DEVIATION REQUEST (Attach diagrams, figures, and other documentation to clarify request)

HILLSIDE AT LORSON RANCH

**DEVIATION 3
 EXHIBIT**

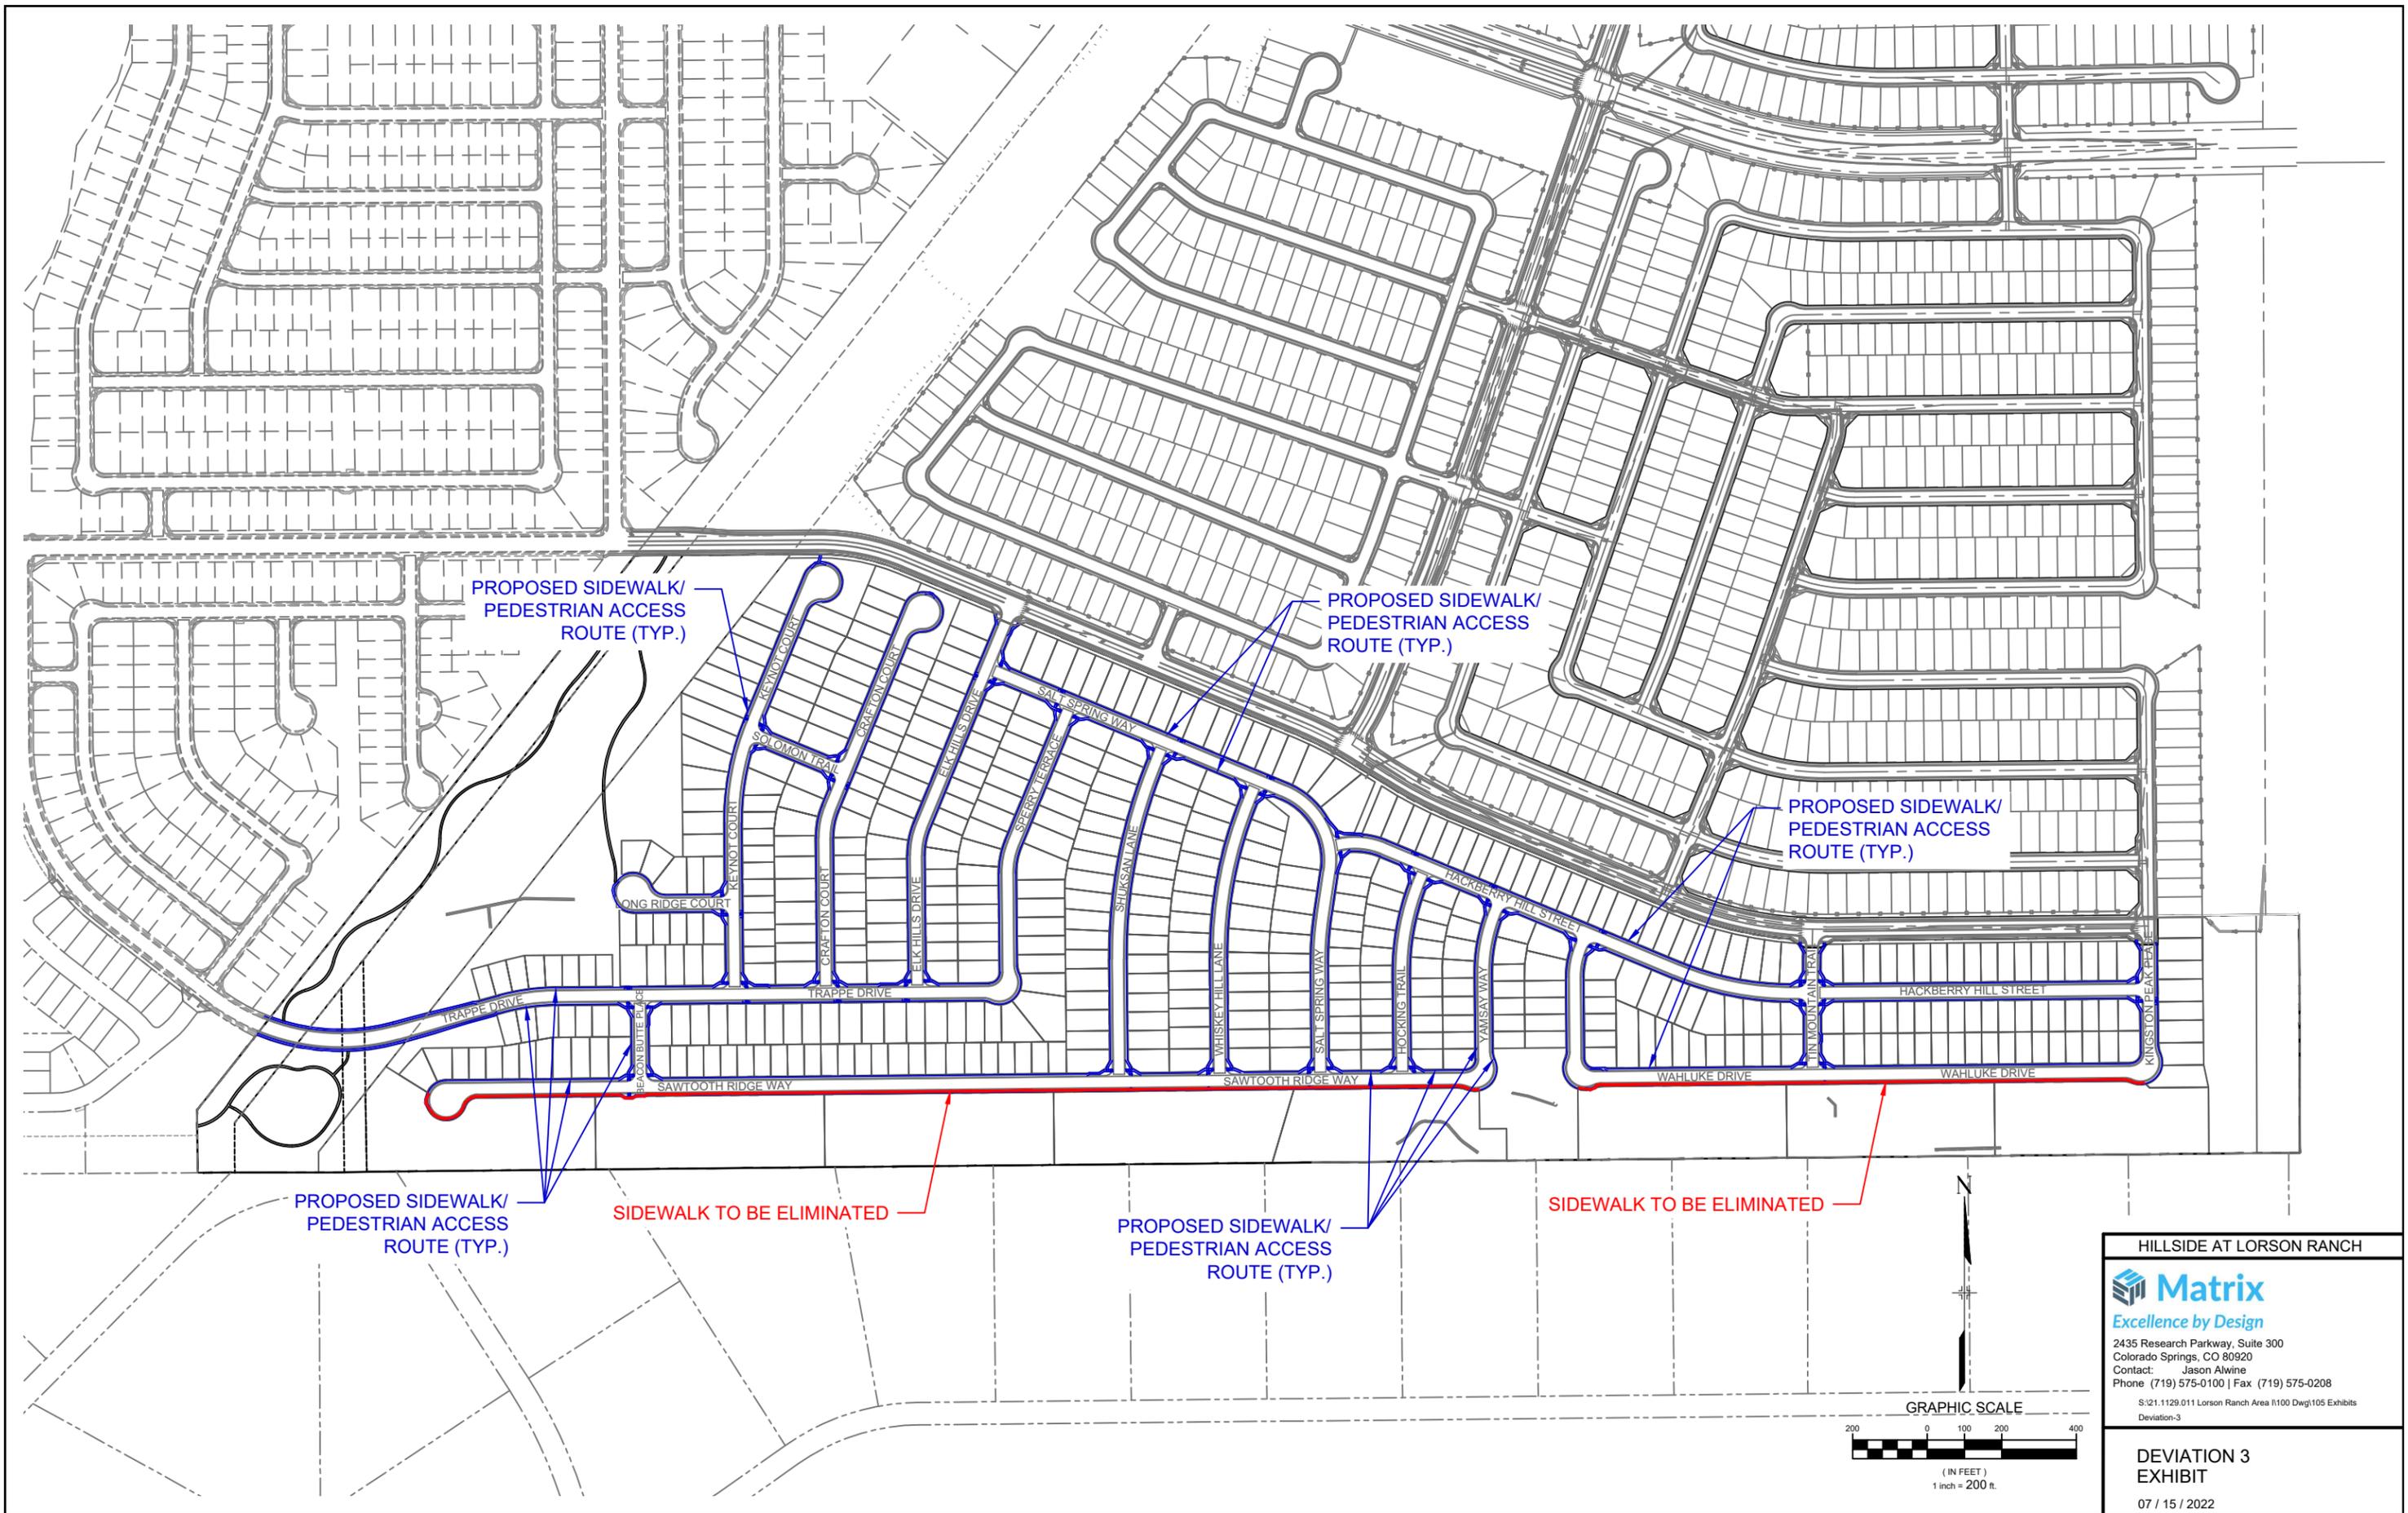
Allow only one five-foot-wide sidewalk along the north side of Sawtooth Ridge Way and Wahluke Drive to eliminate long lengths of sidewalk along the fronts of the 2.5 acre lots.

The proposed alternative is to construct a five-foot-wide sidewalk on the north side of Sawtooth Ridge Way and Wahluke Drive only. The ECM standard is for both sidewalks to be constructed along an urban local roadway.

The current standard will impose an undue hardship on the 2.5-acre lot homeowners. Each homeowner would be burdened with excessive snow and weed removal along their portion of sidewalk frontage. A typical homeowner within the Hillside at Lorson Ranch would only need to maintain an approximate 50-foot length of sidewalk while the 8 large lot homeowners would need to maintain approximately 600 feet. The sidewalk along the north side of Sawtooth Ridge Way and Wahluke Drive will provide adequate pedestrian access routes to open spaces, pocket parks and other facilities as well as connections to all other roadways within Hillside at Lorson Ranch.

Eliminating the sidewalk along the south side of Sawtooth Ridge Way and Wahluke Drive will not hinder pedestrian movements throughout the development and will achieve the intended result with a comparable design. The sidewalk along the north side of Sawtooth Ridge Way and Wahluke Drive will provide adequate pedestrian access routes to open spaces, pocket parks and other facilities as well as connections to all other roadways within Hillside at Lorson Ranch.

This request has been determined to have met the criteria for approval. A deviation from Section 2.5.2.(C2) of the ECM is hereby granted based on the justification provided.
